U.S. GEOLOGICAL SURVEY
RESEARCH REACTOR
LICENSE NO. R-113
DOCKET NO. 50-274

RESPONSE TO NRC STAFF REQUEST FOR
ADDITIONAL INFORMATION
FOR LICENSE RENEWAL REVIEW
APRIL 1, 2016

Reference: U.S. Geological Survey TRIGA Reactor (GSTR), Docket 50-274, License R-113, Request for Additional Information (RAI) dated February 8, 2016

Subject: Responses to RAI questions

Criticality approach curve

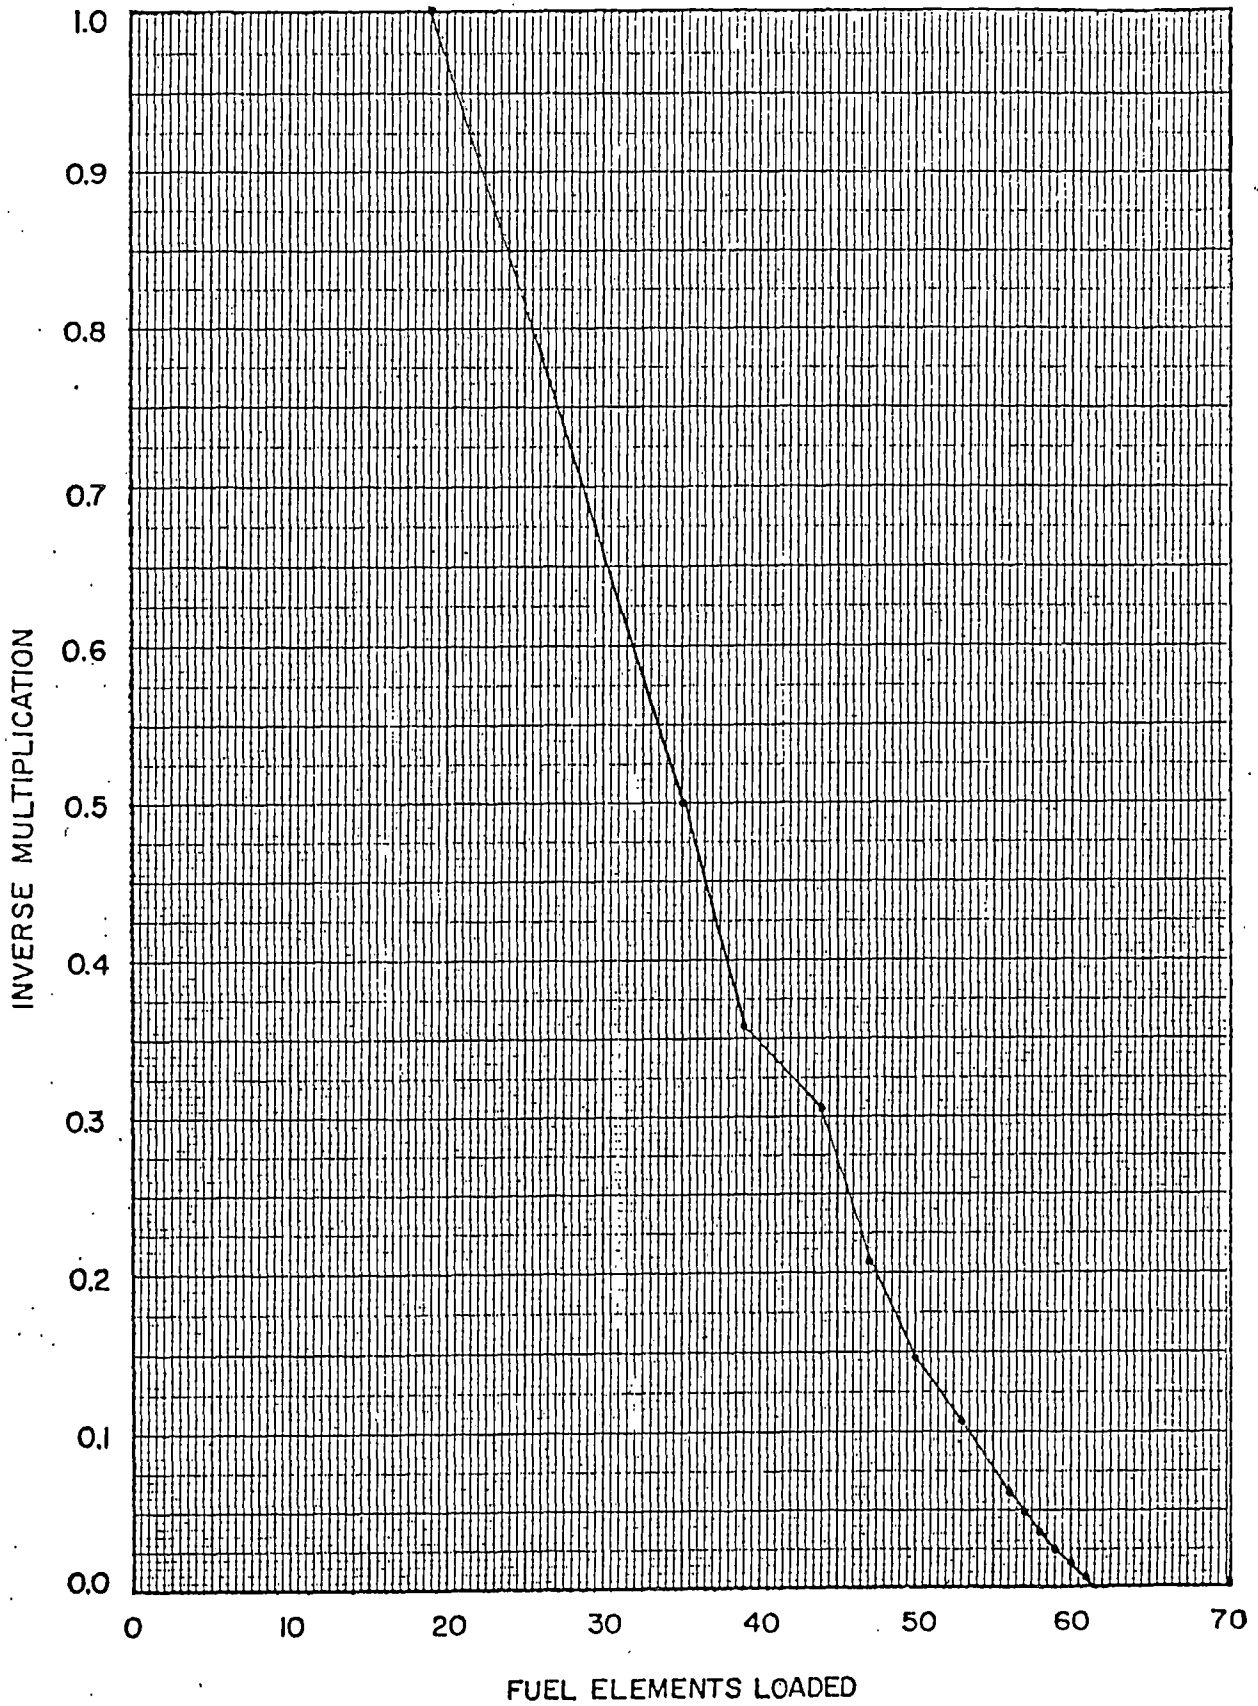
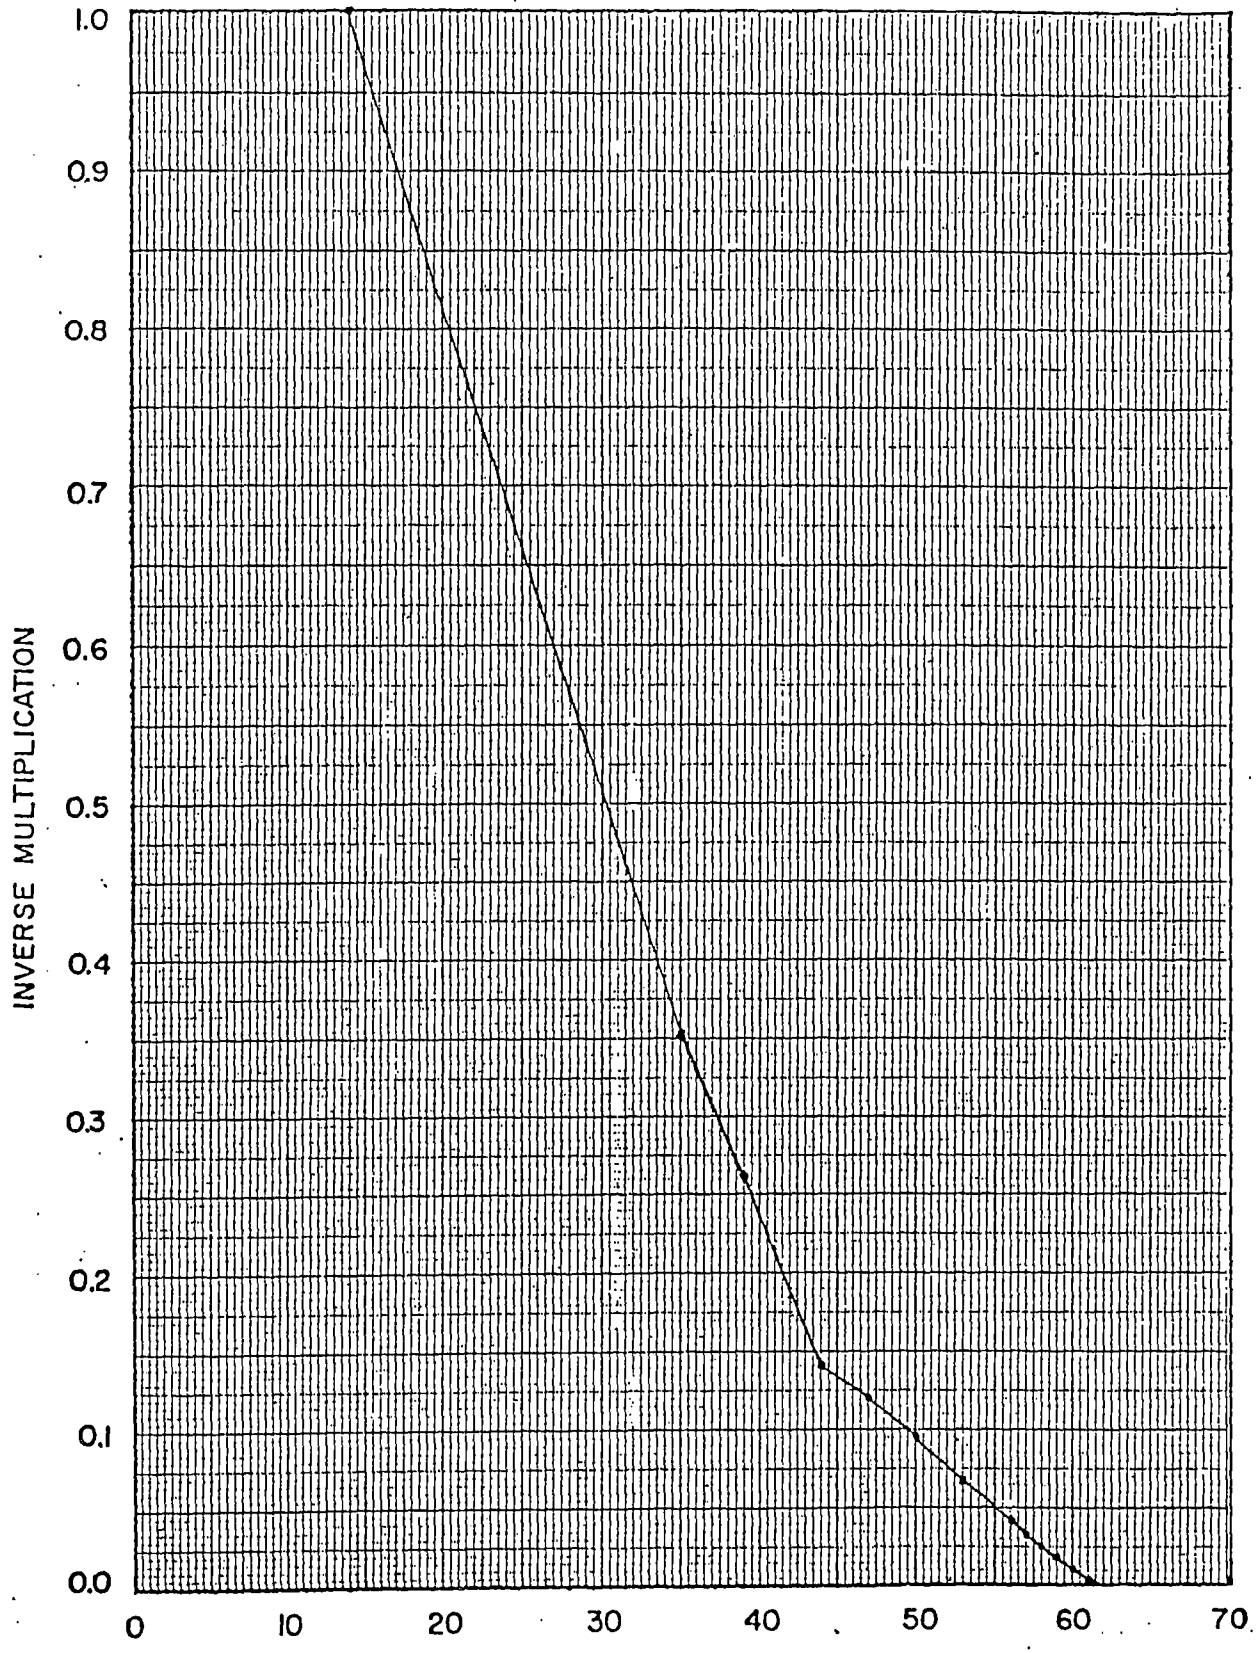
The USGS SAR, Section 9.2.1, "Fuel Storage Racks," provided information concerning the storage of the USGS TRIGA fuel, including a statement that the keff was measured to be below the limit of 0.9. However, it is not clear if this applies to racks located in both the in-tank and the fuel pit locations. NUREG-1537, Part 1, Section 9.2, "Handling and Storage of Reactor Fuel," provides guidance that the licensee should provide an analysis that shows that the keff for fuel storage, under all conditions, is less than 0.9. Provide an analysis or discussion that demonstrates that the fuel storage keff is less than 0.9 under all conditions, or justify why no explanation is needed.

The limiting configuration for fuel storage Keff is water-moderated hexagonal fuel racks that hold up to 19 fuel elements. At optimum spacing and water moderation, a TRIGA reactor needs approximately 54 fuel elements to achieve criticality. A criticality analysis performed by General Atomics (see attachment 1) that shows that the Keff in this 19-element rack is well below 0.8 in a worst case, water-moderated condition.

Figures 1 and 2 show two of the three inverse multiplication curves for the loading of the USGS core. The one not shown gives a sizably lower multiplication until the last few loading steps.

it is shown that approximately 42 to 47 fuel elements are necessary to give a $K = 0.8$. Checking the loading curves for a more recent, similar reactor produced similar results. Thus a flooded storage well with a fully loaded single storage rack, containing 19 fuel elements, clearly has a K less than 0.8. A flooded storage well with two fully loaded storage racks stacked vertically also clearly has a K less than 0.8, especially when the following items are considered:
